**Florida  
Power**  
CORPORATION

SUBJECT: Crystal River Unit 3  
Operating License No. DPR-72  
Docket No. 50-302

In your letter of May 17, 1978 you requested Florida Power Corporation to submit additional information concerning the movement of heavy loads near spent fuel at Crystal River Unit 3.

FPC RESPONSE TO NRC REQUEST FOR ADDITIONAL INFORMATION

FIGURE 1-11  
(AM 48 1/76)  
(DWG. NO. L-001-032)

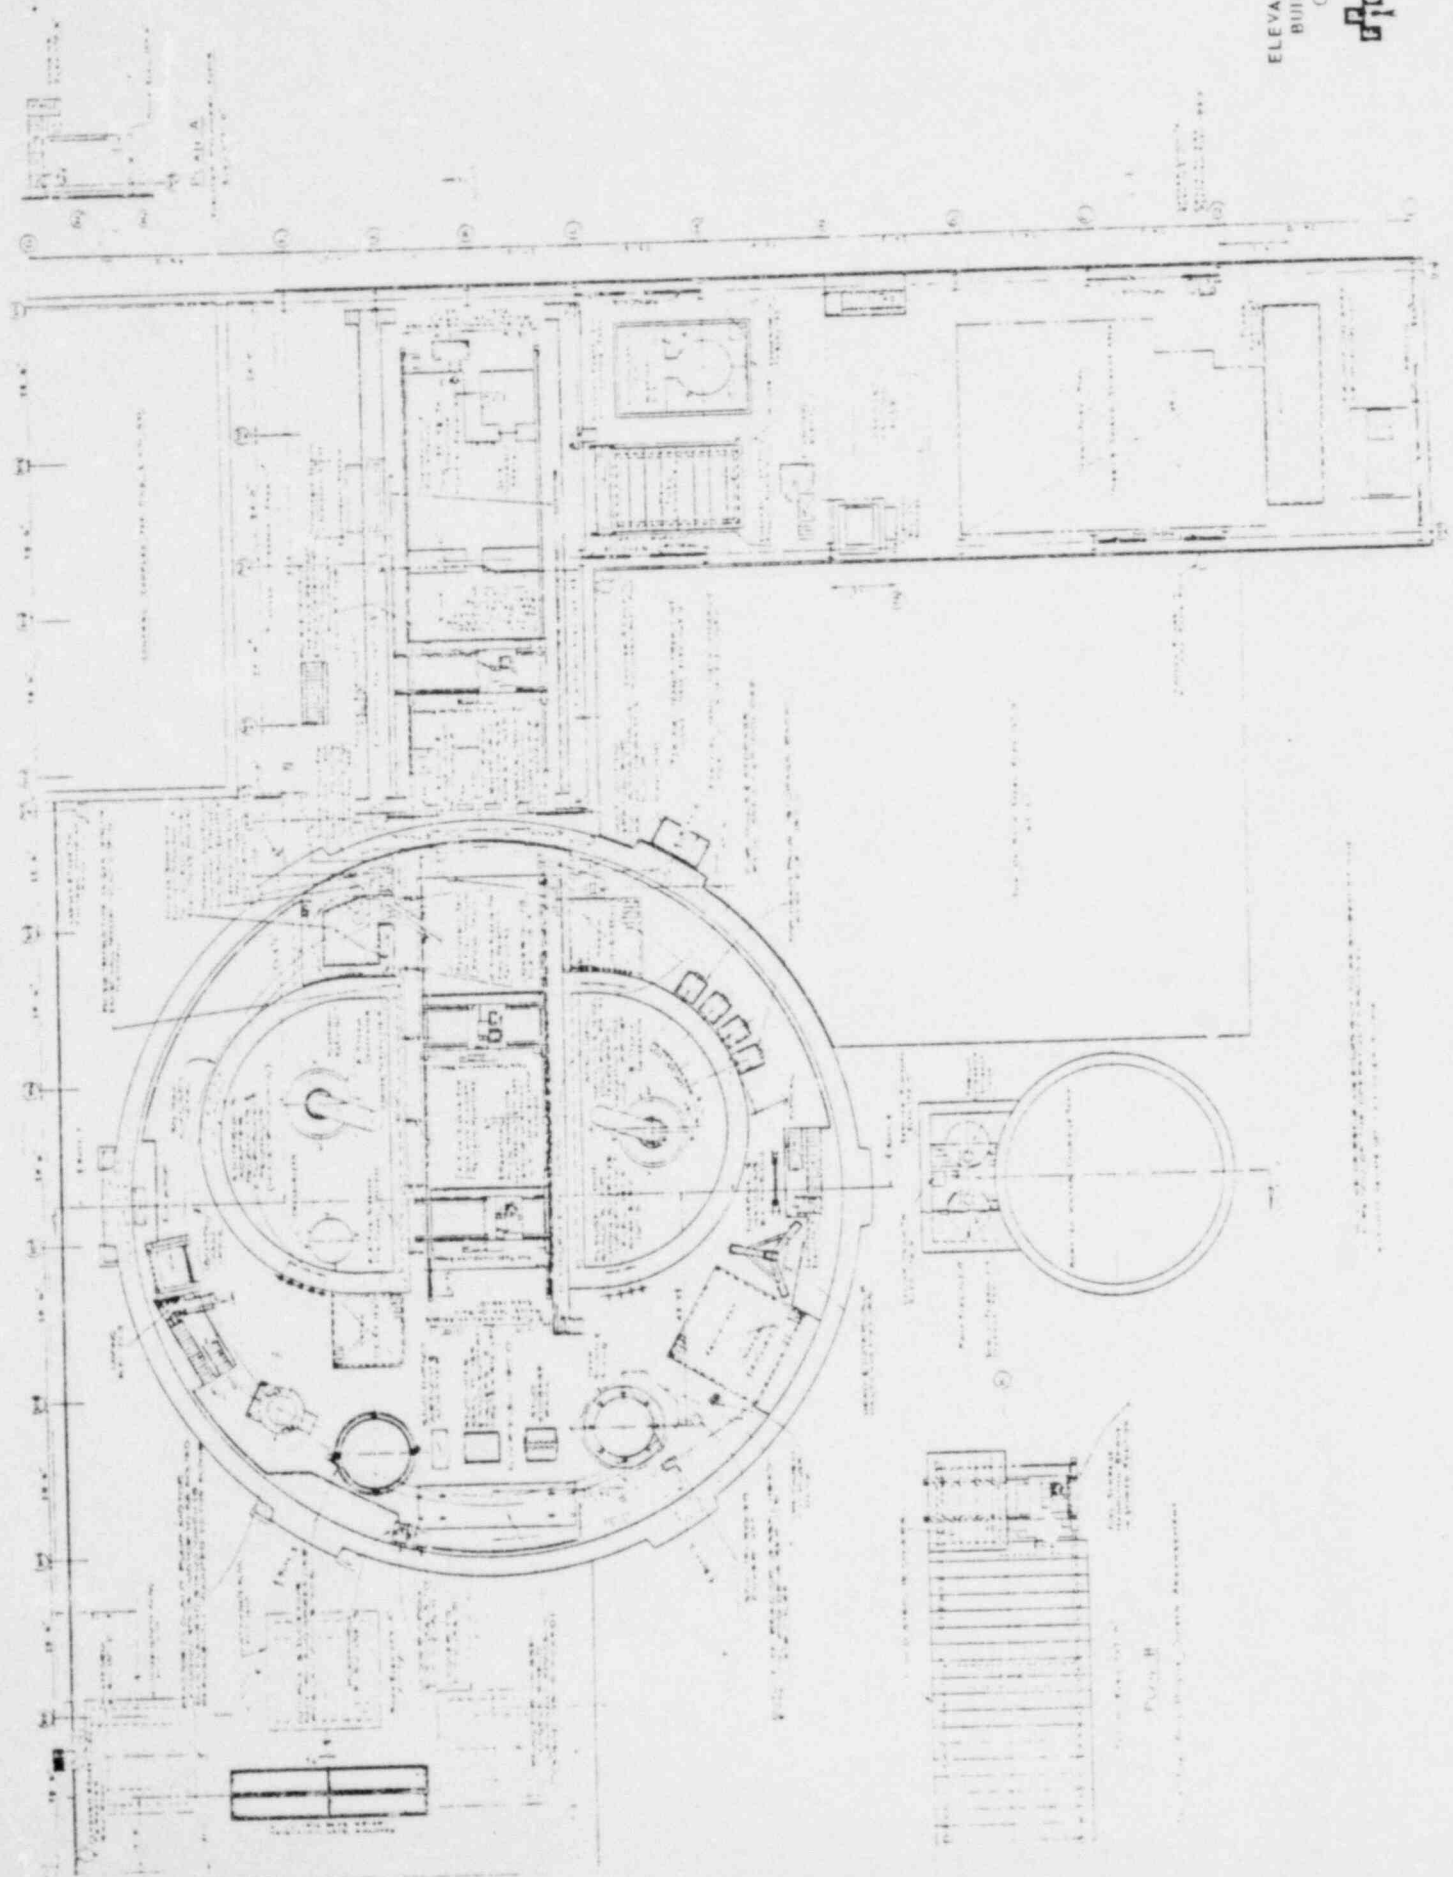
1. Provide a diagram which illustrates the physical relation between the reactor core, the fuel transfer canal, the spent fuel storage pool, and the set down, receiving or storage area for any heavy loads moved on the refueling floor.

The attached Crystal River Unit 3 FSAR Figure 1-11, Elevation 160'-0" and Auxiliary Building Elevation 162'-0", provides the information requested in Item 1.

Figure 1

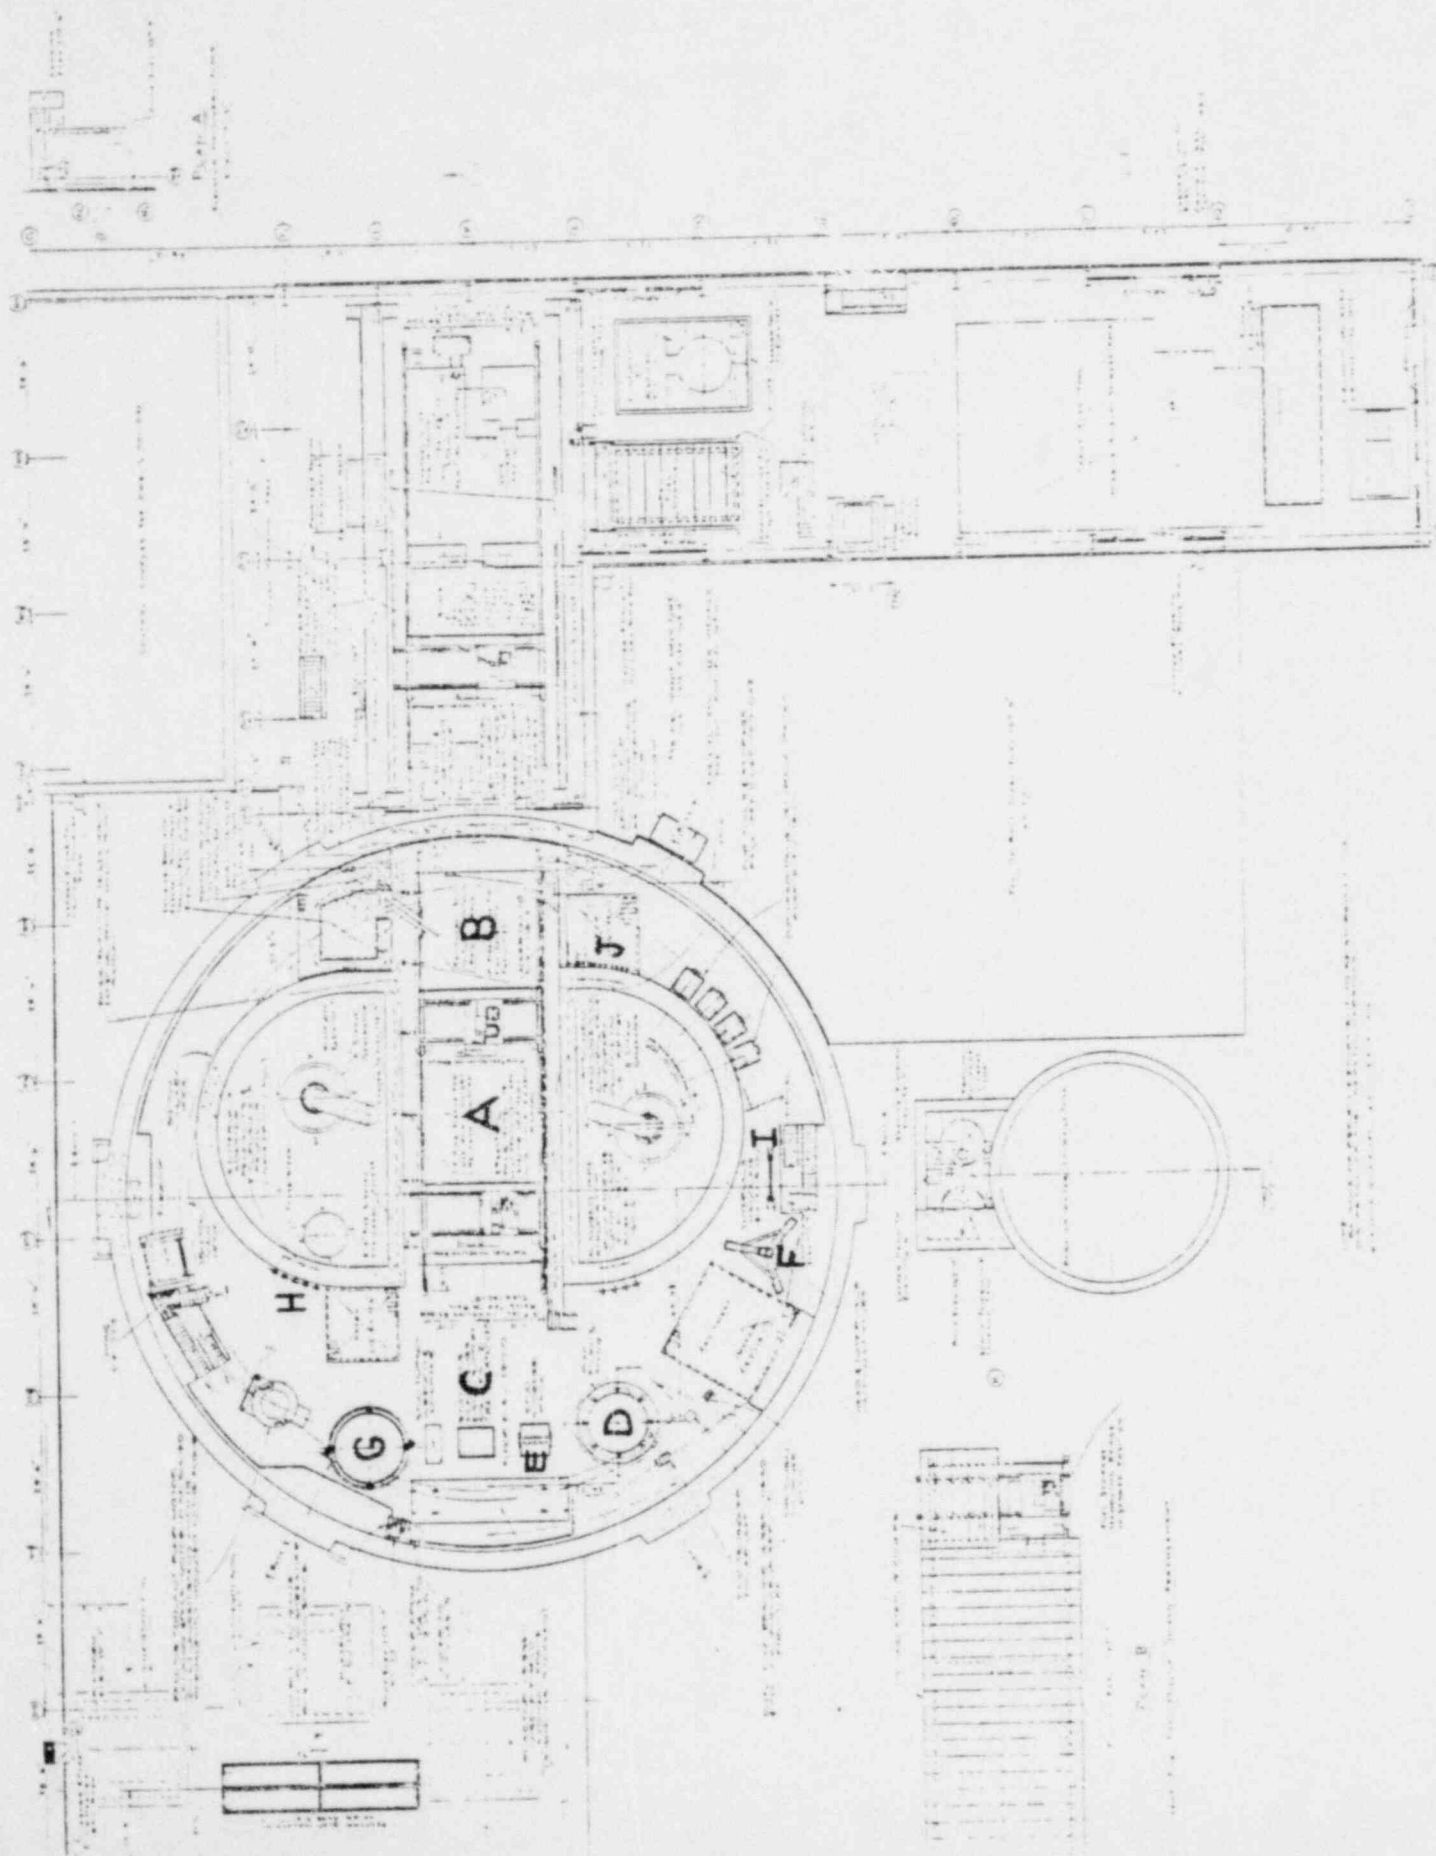
2. Provide a list of all objects that are required to be moved over the reactor core (during refueling) or the spent fuel storage pool. For each object listed, provide its approximate weight and size, a diagram of the movement path utilized (including carrying height) and the frequency of movement.

- (1) The movement path locations designated in this table are shown on Figure 1 attached.
- (2) The heights indicated are approximate heights above the R.V. flange. The top of the fuel core is approximately 11 feet below the top of the flange.
